**VILLAGE OF SUGAR GROVE
BOARD REPORT**

TO: VILLAGE PRESIDENT & BOARD OF TRUSTEES
FROM: WALTER MAGDZIARZ, COMMUNITY DEVELOPMENT DIRECTOR
DANIELLE MARION, PLANNING & ZONING ADMINISTRATOR
SUBJECT: ORDINANCE: FINAL PUD PLAN, PRAIRIE GROVE COMMONS UNIT 2 LOT 1 (CASEY'S)
AGENDA: MARCH 21, 2023 VILLAGE BOARD MEETING
DATE: MARCH 10, 2023

Shall the Village Board discuss a final Planned Unit Development (PUD) plan for Lot 1 in Prairie Grove Commons Unit 2 for a Casey's gas station and mini-mart.

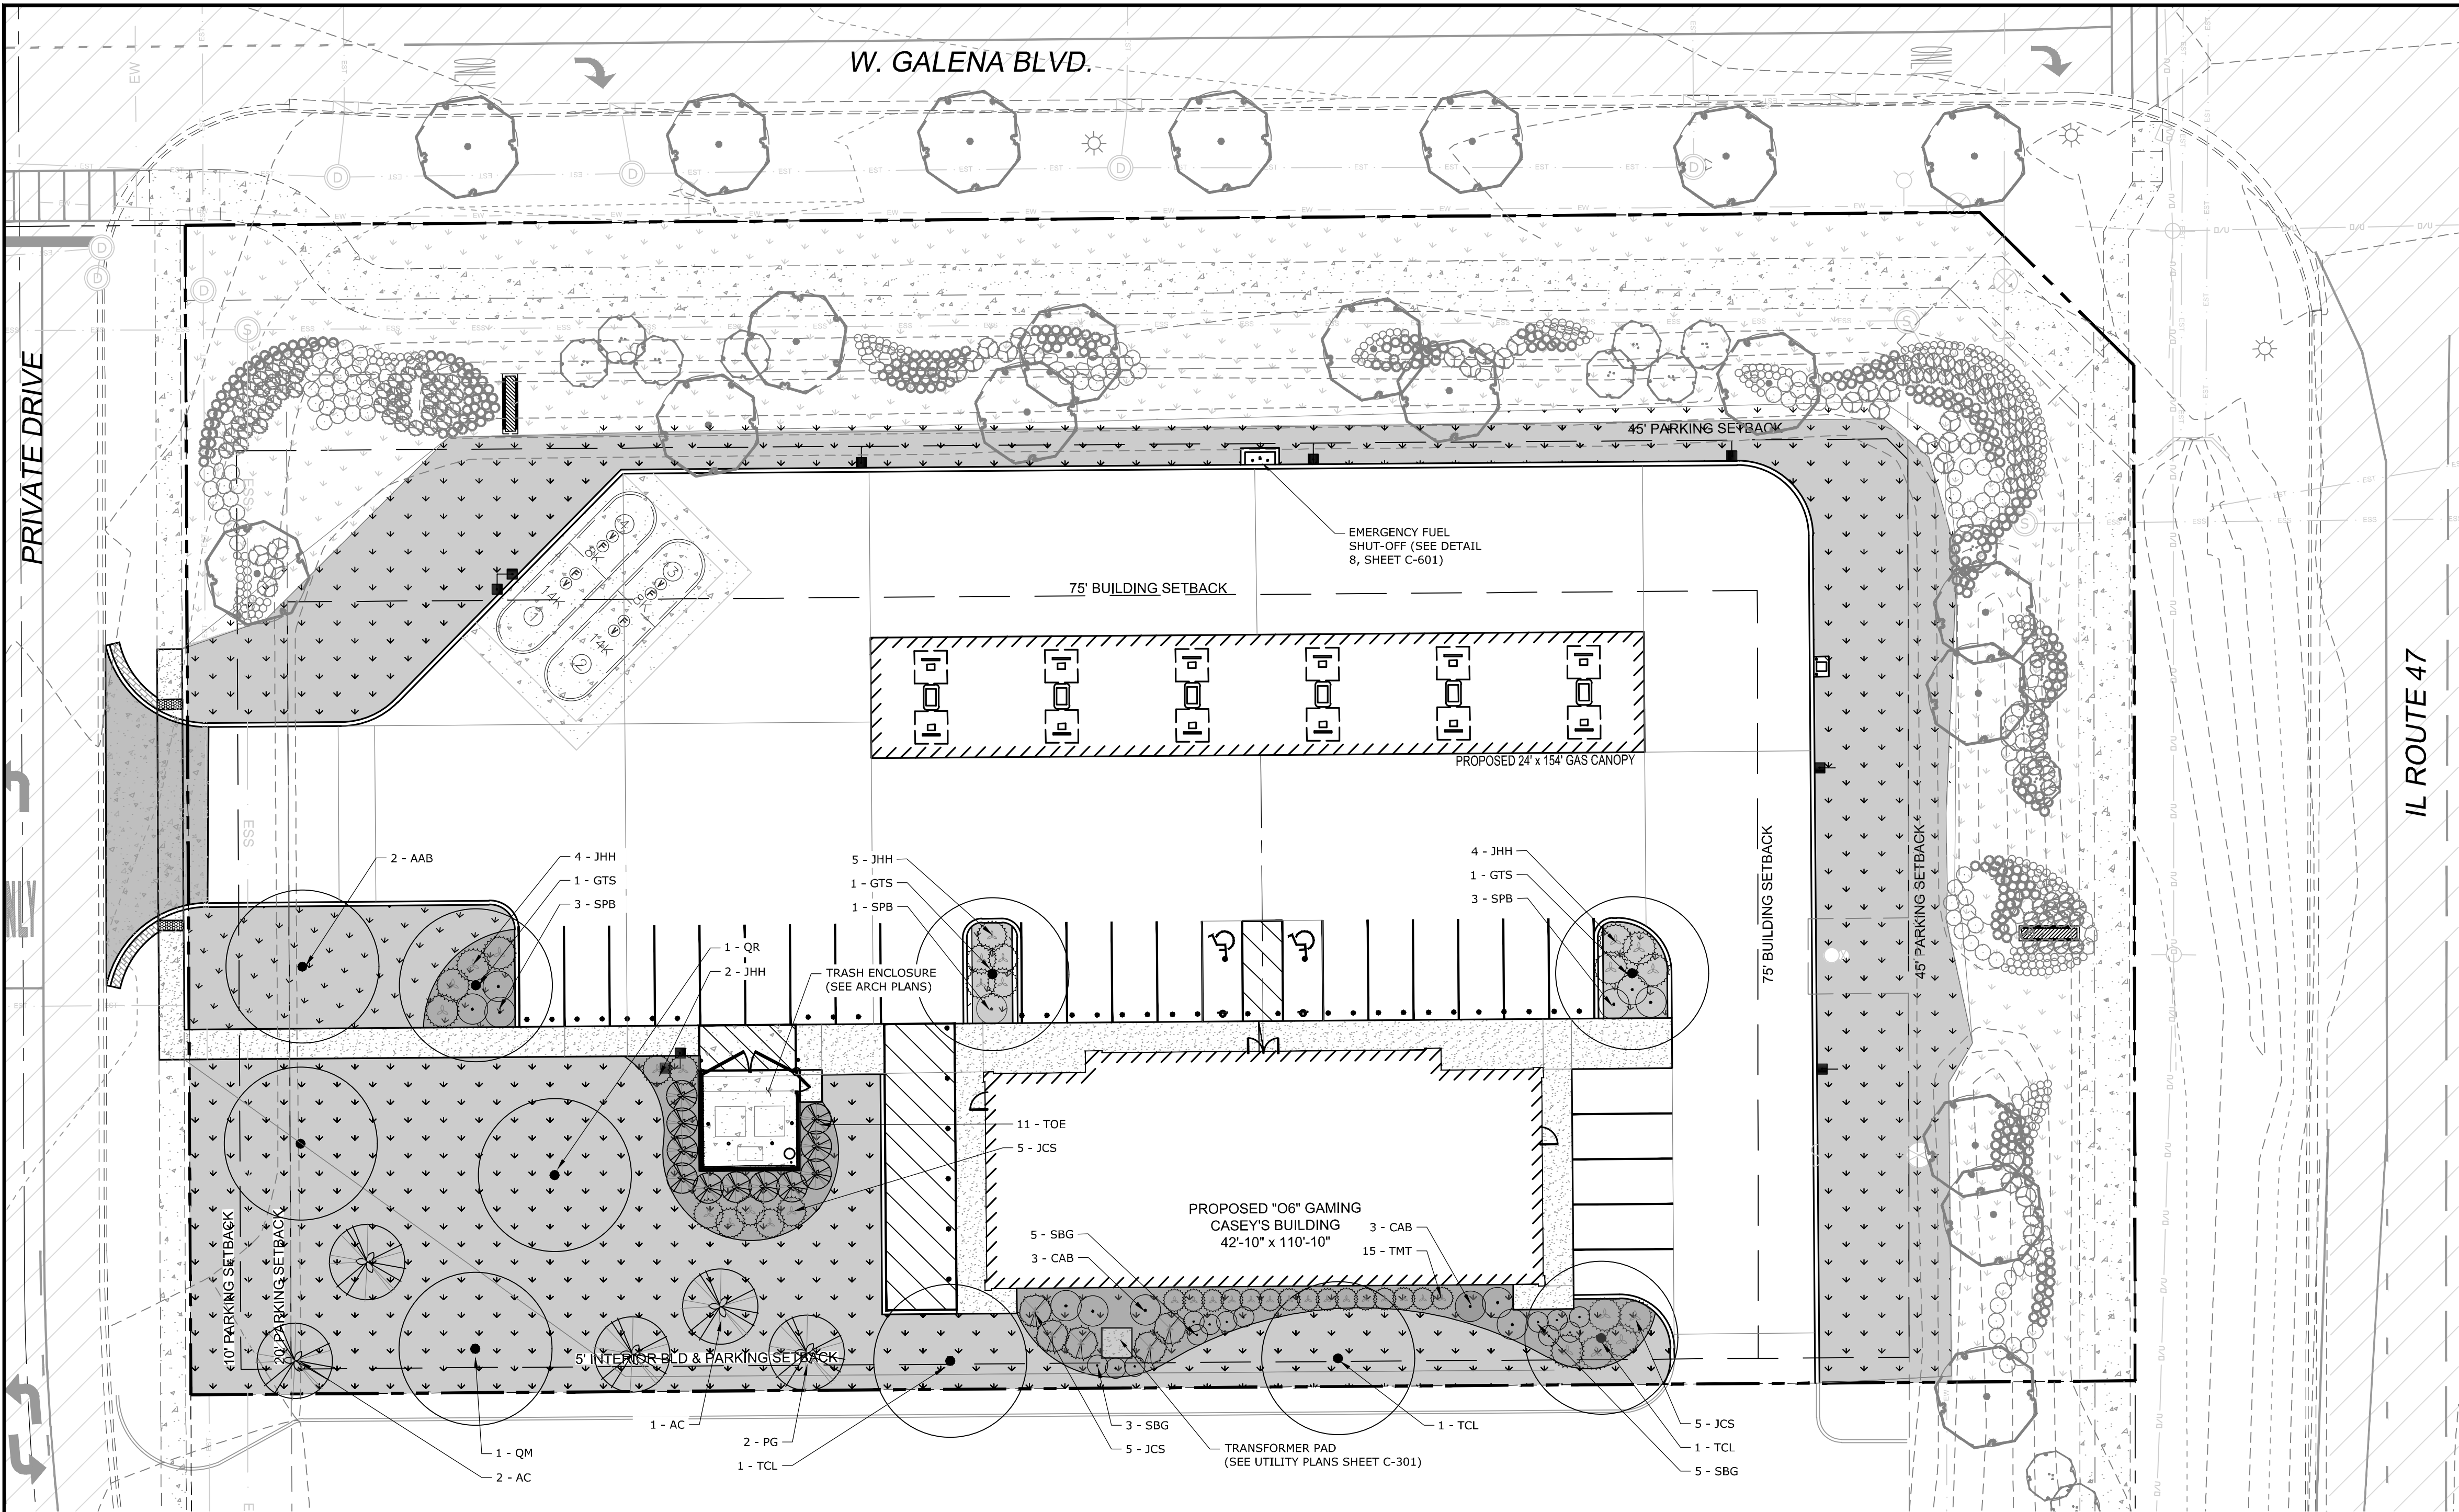
The Planning Commission recommends approval of the final PUD plan for Lot 1 in Prairie Grove Commons Unit 2, subject to the addition of a bicycle rack in a location to be determined by the applicant and Village staff. The applicant had no objection to adding the requested bike rack.

After careful consideration, the Planning Commission recommends the Village Board **approve** the final PUD plan for Lot 1 in Prairie Grove Commons Unit 2, subject to the addition of a bike rack in a location to be determined between the applicant and Village staff.

1. Site Plan by Gleason Architects dated July 25, 2017
2. Landscape Plan by Heller & Associates, LLC dated July 27, 2017
3. Elevation Plan by Gleason Architects dated May 23, 2017
4. Sign Plan by Archetype dated June 6, 2017 revised July 27, 2017
5. Site Improvements by Caldwell Engineering, LTD dated August 12, 2017
6. Photometric Plan by Cree dated September 26, 2017
7. Trash Enclosure Plan by Gleason Architects dated July 25, 2017
8. A bicycle rack be added to the site development plan

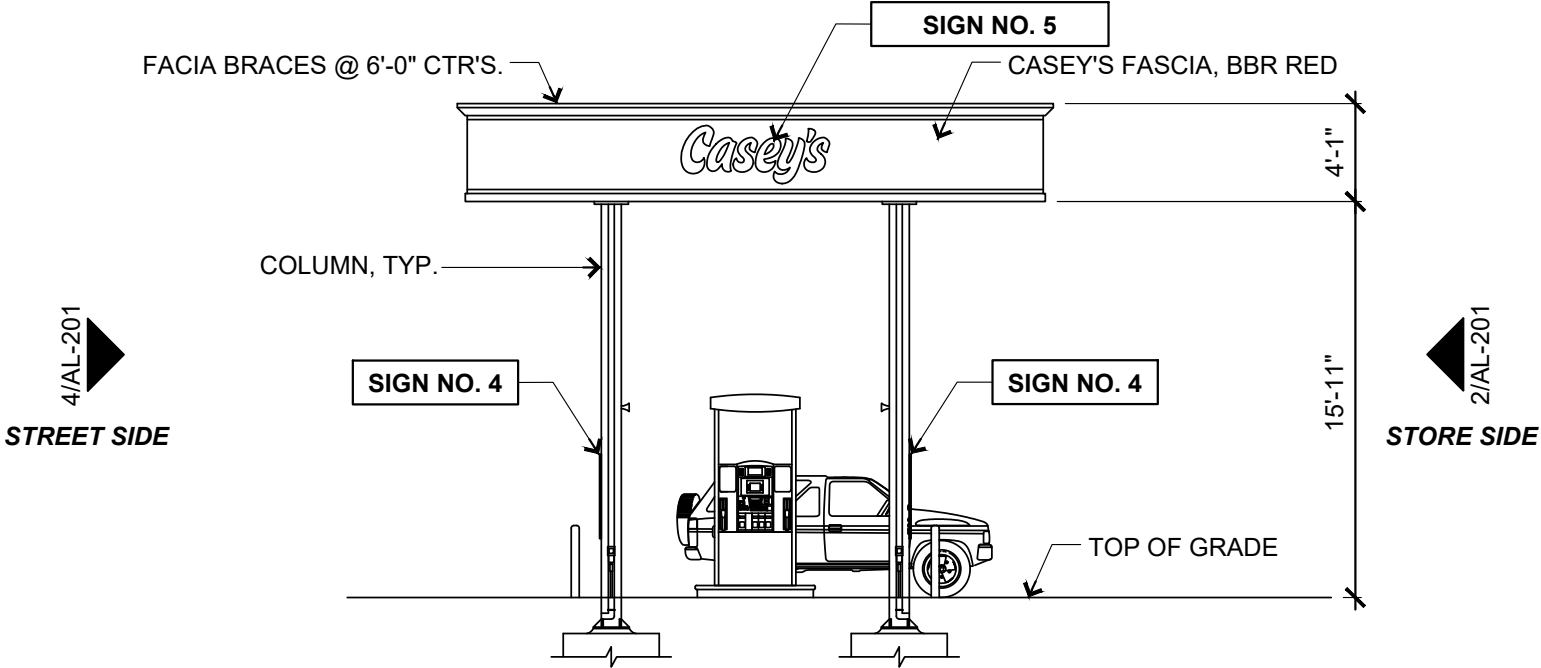
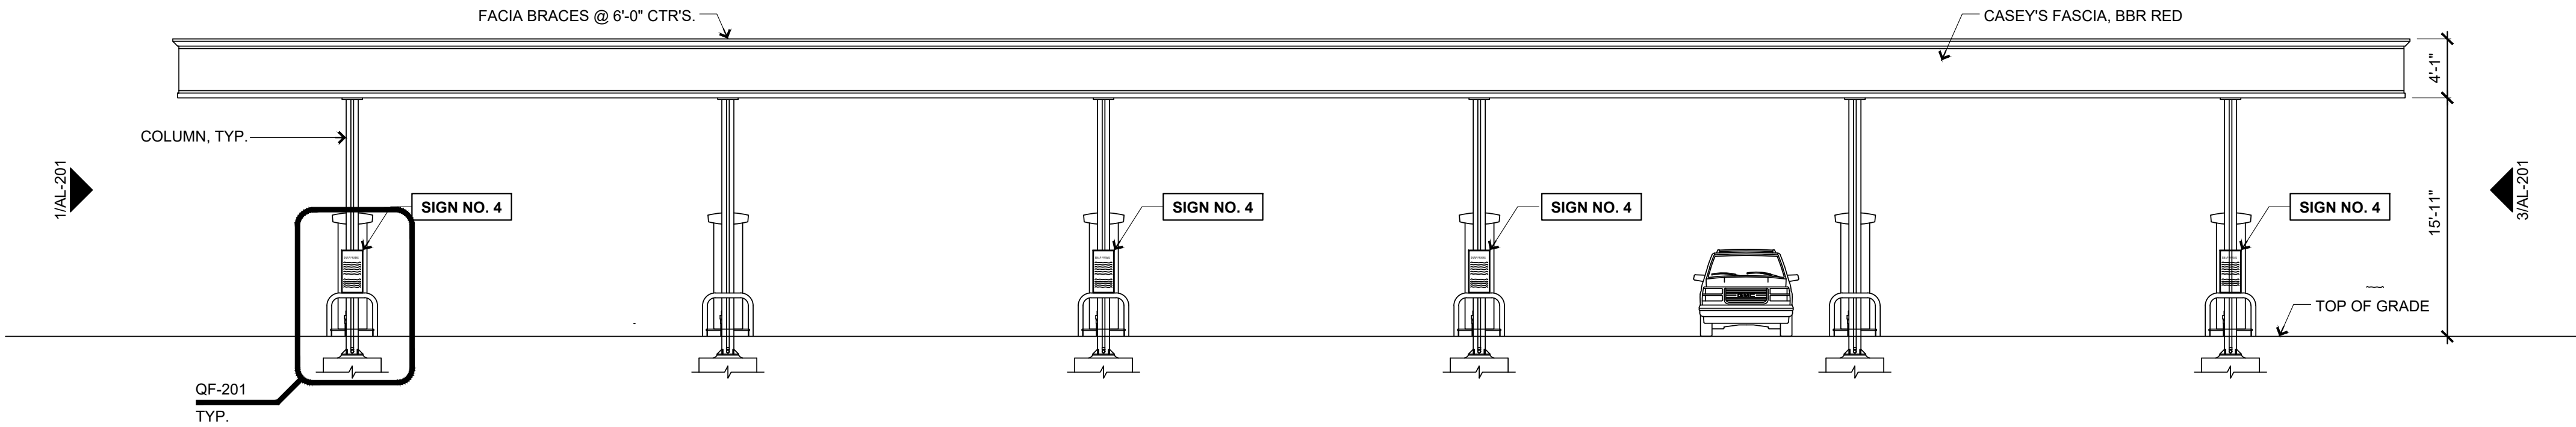
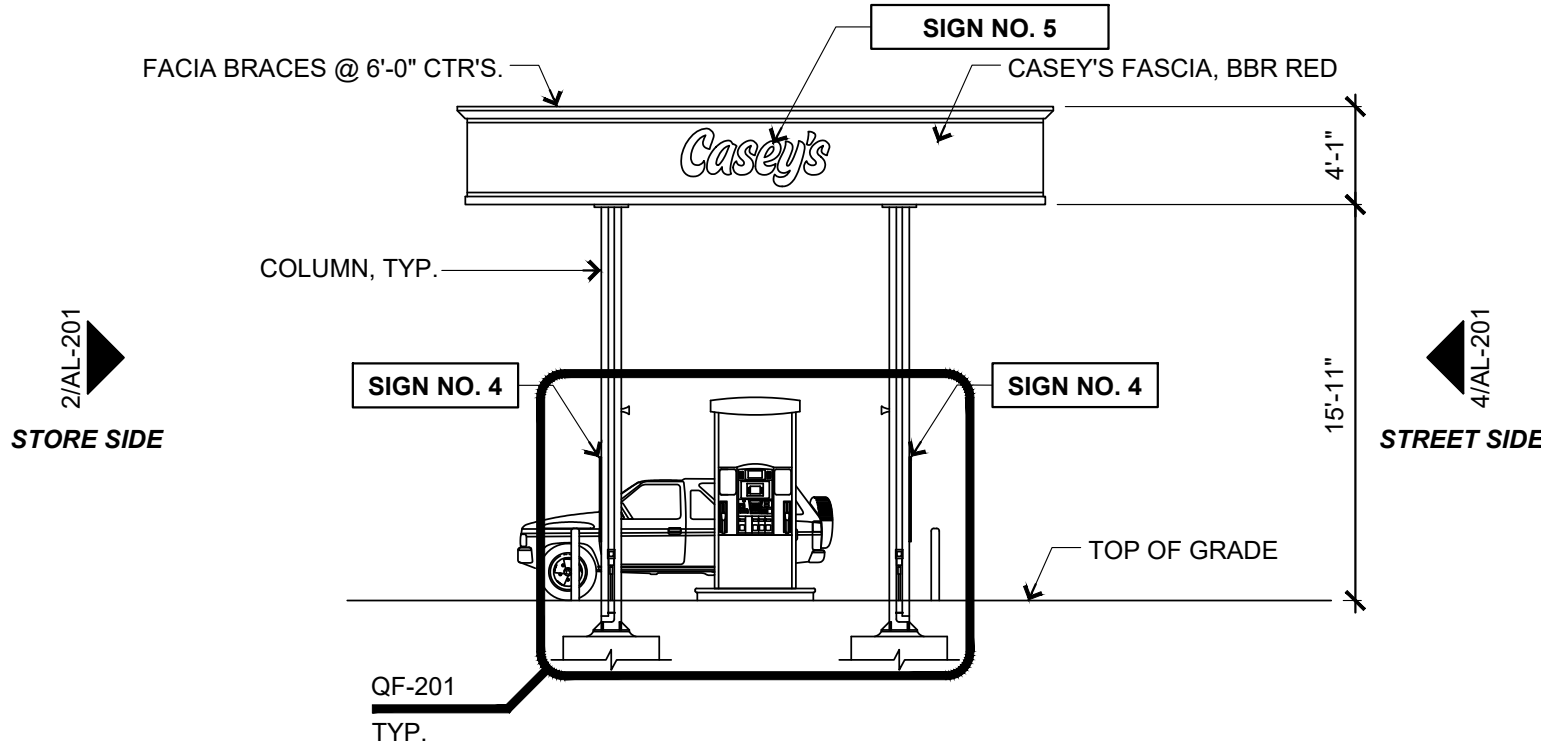
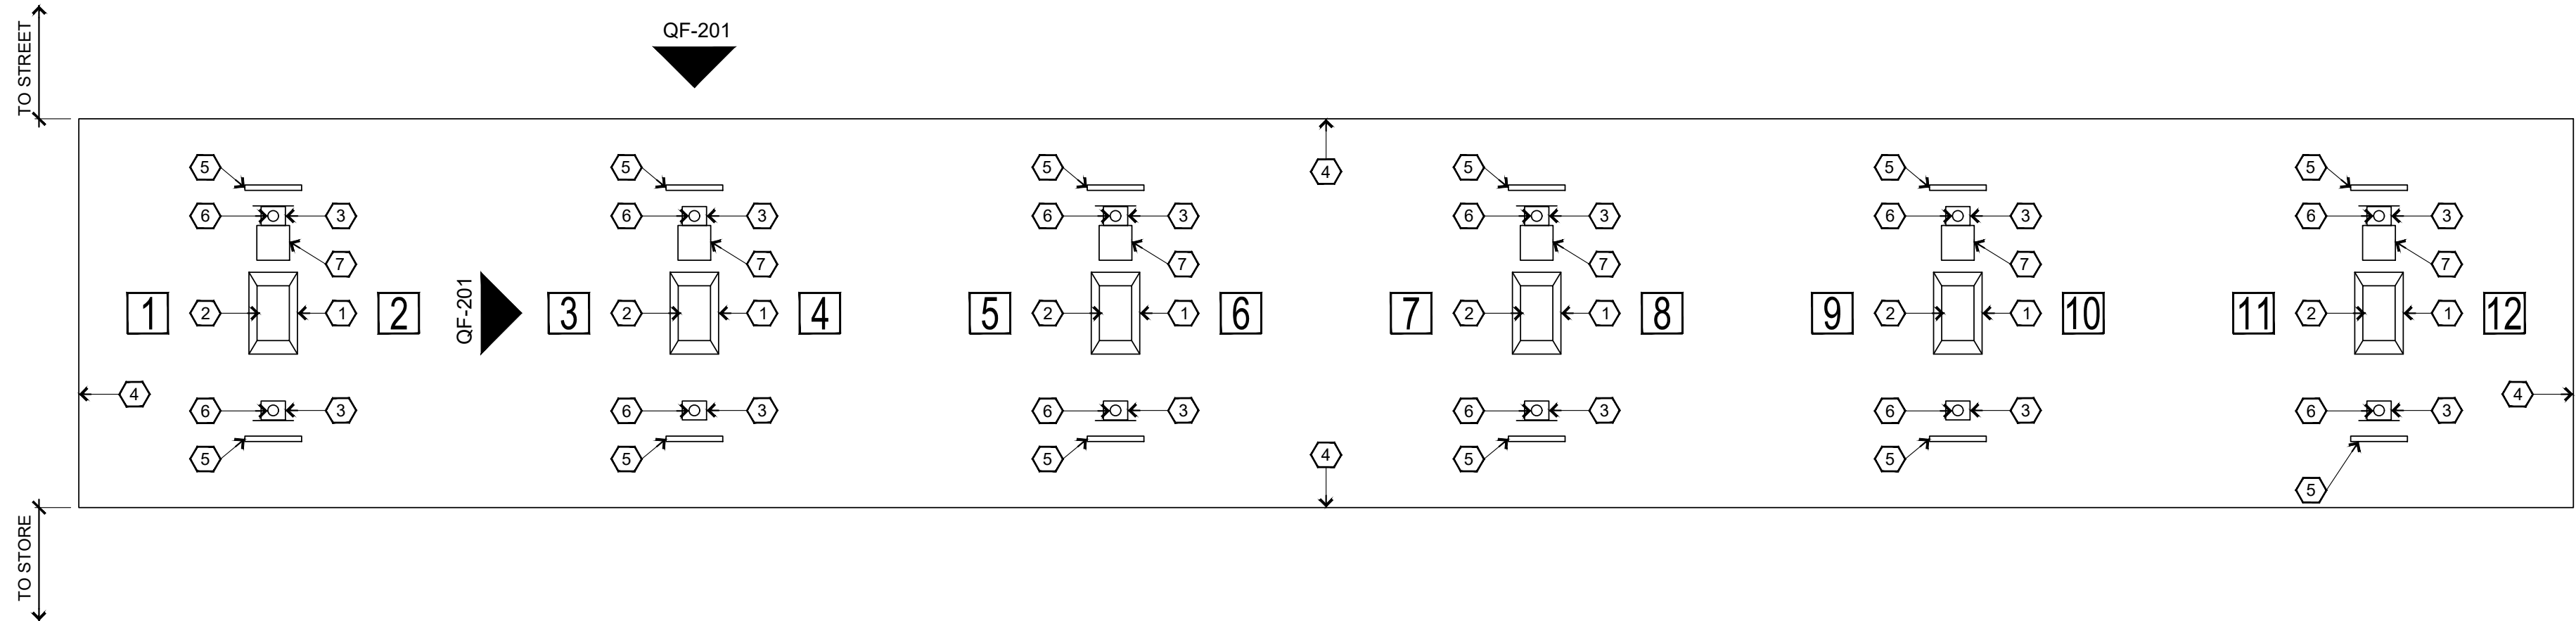
One matter that was not addressed by the Planning Commission or in the Prairie Grove Commons PUD documents is the design of the pump island canopy. The Village has, in the past, required gas stations to wrap the support columns in masonry to match or compliment the principal building. Casey's proposed fuel island canopy has exposed metal support columns. The Village Board should provide Casey's and Village staff with direction on the preferred appearance of the support columns.

That the Village Board approve an Ordinance approving the final Planned Unit Development (PUD) plan for Lot 1 in Prairie Grove Commons Unit 2 for a Casey's gas station and mini-mart convenience store, subject to direction on the fuel island canopy support columns.
